September 9th, 2010

On behalf of the U.S. Nuclear Regulatory Commission (NRC), I am responding to your letters, dated April 8, 2010, to Chairman Gregory B. Jaczko and the Advisory Committee on Reactor Safeguards. In the letters, you expressed your general concerns with "Industry Standards in Licensed Operator Training," and your specific concerns with the NRC's Generic Fundamentals Examination (GFE) Question Bank. You also reiterated your specific concerns, initially provided to us in May 2006, regarding GFE Question P415. Again, I apologize for our failure to complete our response to the specific concerns that you raised in May 2006.

Staff Response to Comments Regarding Specific GFE Questions

Fig. 6

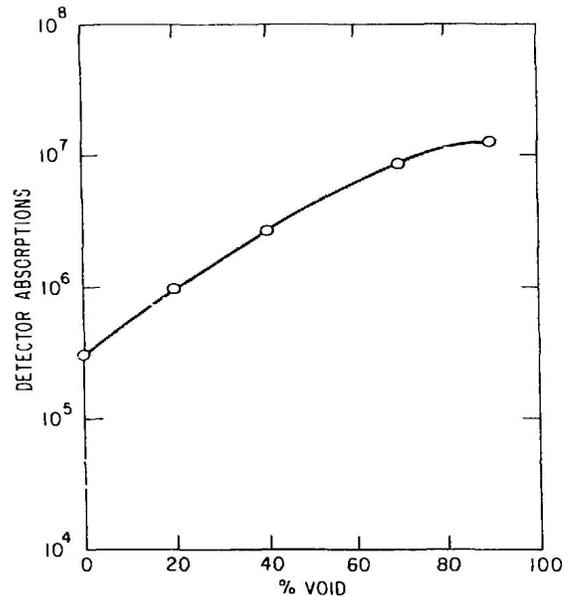
When the negative effects of decreasing photoneutron source strength and decreasing K_{eff} are combined, there is a total core neutron decrease factor of between 1.0×10^{-2} and 1.0×10^{-3} from complete homogeneous core voiding. When the effect of the increased neutron transmission probability is added, the rate of neutron detection by the SRDs is expected to increase by a factor of between 1.0×10^1 and 1.0×10^2 from complete homogeneous core voiding. This range is supported by figure 6 (below) from ANL-81-75.

The graph in figure 6 shows a curve that stops at about 90 percent core voiding. ANL-81-75 states that model calculations near 100 percent are not accurate and, therefore, are not plotted. ANL-81-75 goes on to state:

“Even though the neutron source strength is decreasing, the transmission probability (i.e., to the detector) is increasing at a greater rate. The result is a continually increasing count rate.”

It is important to note that ANL-81-75 begins its analysis no sooner than thirty minutes after a scram, when the photoneutron source strength is decreasing at a moderate rate. If the analysis had begun sooner, the photoneutron source strength would have been decreasing at a faster rate, and the SRD response would have been different. If the analysis had begun immediately after a scram, it is possible that the SRD response would have decreased initially due to the high rate of decay of the photoneutron source strength.

There are several reasons why the findings in ANL-81-75 are not directly applicable to P415:

- ANL-81-75 uses the reactor characteristics of TMI-2 in its modeling. Some nuclear power plants do not use installed neutron sources, making the photoneutron source the dominant contributor of source neutrons for days (not just hours) following a scram.
- ANL-81-75 analyzes SRD response from thirty minutes to three hours following a reactor scram. P415 does not state a specific time period for consideration.
- ANL-81-75 converts the negative reactivity from the control rods and burnable poisons to equivalent soluble boron for modeling purposes. When core voiding occurs, much of the soluble boron will be expelled from the core, which will result in a higher than expected value for core K_{eff} from the model.

Summary and Conclusion: Two Westinghouse MCD texts with different publishing dates -- 1983 and 1991 -- differ in their descriptions of excore SRD response to homogeneous core voiding. Each text supports a different answer to GFE question P415.

Conclusion: Presently, a single definitive correct answer for P415 has not been determined. Therefore, P415, and similarly affected questions, will be removed from the GFE question banks.

Refer to the graph of critical boron concentration versus burnup for a nuclear reactor core following a refueling outage (See figure below.).

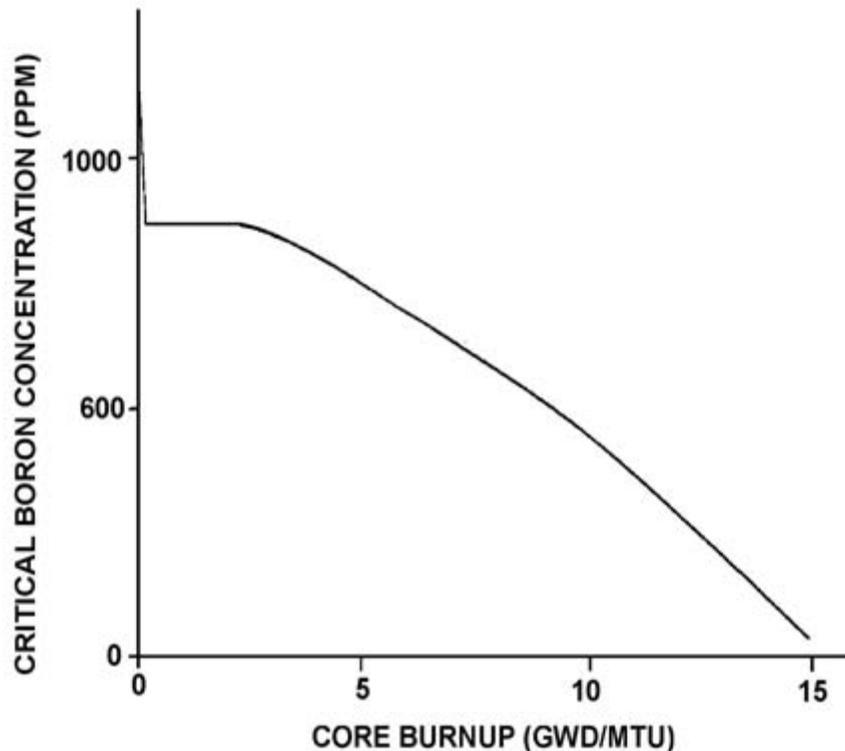
Discussion: An assertion is made that PWR critical boron curves provided in the GFE bank questions represent older core designs (prior to 1990) instead of modern cores (1990 and later). The staff acknowledges that reactor core designs have changed over time and therefore have different critical boron curves over time. However, the overall shape of the curves from the middle of core life to the end of core life has not changed. Furthermore, the GFE is a generic fundamentals examination and is not designed to test site-specific knowledge. The NRC finds that, as written, this question examines the fundamental concepts of critical boron concentration throughout core life and is therefore appropriate for the GFE exam.

Discussion: An assertion is made that PWR critical boron curves “show a rise in boron concentration shortly after the compensating drop that accounts for initial Xenon-135 buildup.” As discussed above, the staff acknowledges that reactor core designs have changed over time and therefore have different critical boron curves over time. However, the overall shape of the curves early in core life are still “relatively constant.” The NRC finds that, as written, this question properly examines a fundamental concept of critical boron concentration early in core life that is still valid.

Conclusion: P1563 will remain in the GFE question bank.

Conclusion: P1864 will remain in the GFE question bank.
